**REQUEST FOR INFORMATION**

Date of Decision: 18 Oct 2021  
Decision No: 1367  
Registered Reference: SD21A/0233  
Registration Date: 23 Aug 2021.  
Location: 1 Killakee Park Dublin D24 W9T2.

**Fig 1 & 2**  
[above]  
The existing houses at Killakee Park step relative to one-another creating a sawtooth stepped building line. Our proposal conforms to this morphology.

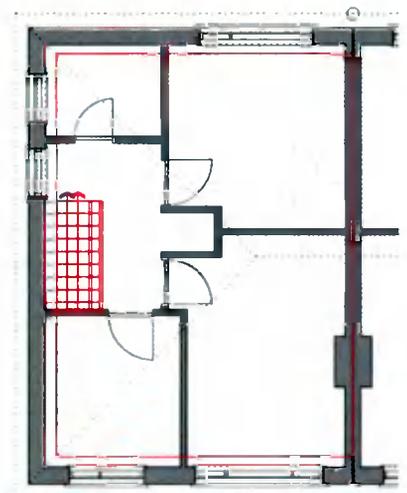
- c) At First floor level the house shall have a front-to-rear building depth that dose not exceed that of the existing house and other houses ion Killakee Park.**

- d) At ground floor level, a rear projection may extend the front to rear building depth beyond that outlined in (c).**

If we were to follow this advice strictly and insulate the building to achieve best practice the internal area would be reduced by between 360mm and 400mm. This reduction would be a compromise for a plan depth which is already small. Most rooms at this level including bedrooms would be reduced by 200mm at two sides. Our follows the front building line but breaches the rear building line so that the ground and first floor have the same footprint which is square on plan and very efficient having a low volume to surface area. The house steps beyond the rear building line by circa 1100mm which we believe is not a significant step. Being to the immediately north of the existing house it will not have a negative shading effect of the existing house. The form of the house is derived from the circulation patterns required for universal access at ground floor and reducing the costly thermal envelope of the building. The house also occupies a far smaller footprint than an existing house which would comply with the design changes in the RFI.

[below]  
Red outline indicates the reduction in floor area relative to the increase in the thickness of the thermal envelope to comply with contemporary standards and future proof a house based on the existing front to back building line.

Our proposal conforms to the stepped building line at Killakee Park. Each pair of houses steps relative to its neighbour as the street progresses from east to west towards the park. Other streets in this area follow a similar morphology. The final house, at each street, steps and is sometimes twisted relative to its neighbours. We have stepped our proposal in line with this context but also twisted the house so it addresses equally the park and the street in line with the dual frontage requirement at section 11.3.2 (ii) Corner development should provide a dual frontage in order to avoid blank facades and maximise passive surveillance of the public domain.

**Fig 6 & 7.**  
[above]  
Option B which retains the existing street, Lime, tree moves the entrance closer than necessary to the junction.

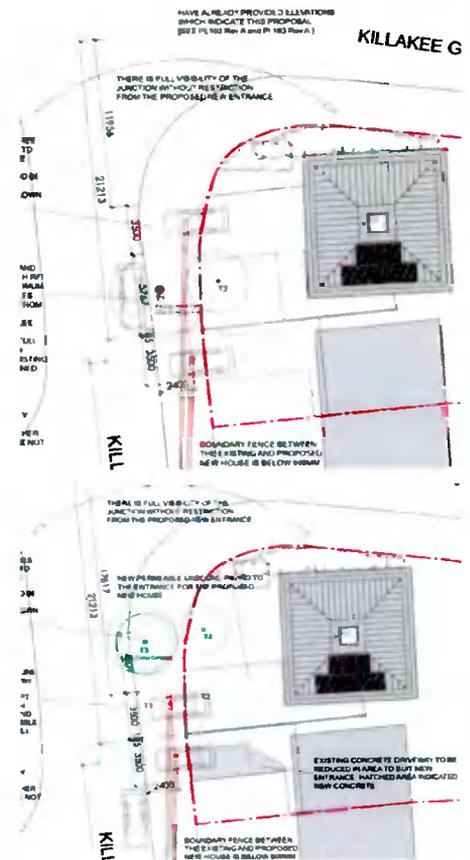
(i) Relocated one or both of the proposed vehicular accesses to as not interfere with the Root Protection Area of the existing tree, Limit the width of each vehicular access point to 3.5m and if possible provide enough separation to allow on street car parking between the accesses.

(ii) If assessment of alternatives under (i) shows there to be no safe alternative to the proposed layout, the applicant will show where a replacement tree would be planted , in the public realm, at the applicant's expense. Assessment under (i) should be demonstrated in this case.

(i) accurate plans demonstrating the provision of a visibility splay 2.0m x 45m in both directions from the entrance. Sight lines should be shown to the near side edge of the road to the right hand side of the entrance and to the centreline of the road to the left side of the entrance (when exiting).

Two options for the entrance locations were provided to the Traffic Department; one which preserves the tree but places the entrance of the new house closer to the junction and another which removes the tree locating the entrance for the new house further from the entrance.

The option which retains the street tree places the entrance within 11.95m of the junction. Option A which removes the tree is 17.61m from the junction and provides a safer entrance with better sight lines. We presented both to traffic and they have accepted that the option which removes the tree is an appropriate and acceptable solution.

[below]  
Option A with proposed location of replacement tree and the safer entrance to the proposed new house approved by traffic.

**Fig 9 & 10**  
[above]

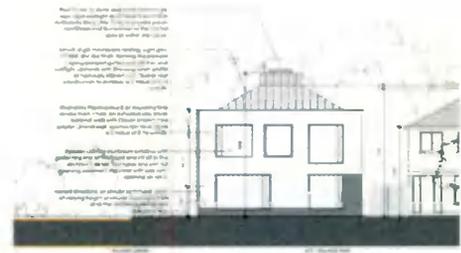
(iv) site elevations at a scale of no less than 1:200, showing the proposed boundary treatment and relative location of the SDCC Street Tree. The Boundary wall at the vehicle access point shall be limited to a maximum height of 0.9m, and any boundary pillars shall be limited to a maximum height of 1.2m, in order to improve forward visibility of vehicles.

**(v) a revised Site Layout Plan showing the extent of the existing concrete on site.**

Drawing T-011 was submitted for comments together with our original elevations which have no boundary treatment at the proposed front garden and entrances to both houses. It also indicates the extent of the concrete pavement at the existing house. A revised drawing of the boundary treatments are not required as there will be no boundary.

The existing front garden has no boundary wall or fence which we propose will continue for the proposed new house. As shown on our plans and elevations the north facing site boundary towards the park will have a hedge creating an appropriate boundary with the path and fronting onto the park..

The drawings submitted at 1:100 clearly show that there is not boundary treatment proposed at the front west facing boundary.
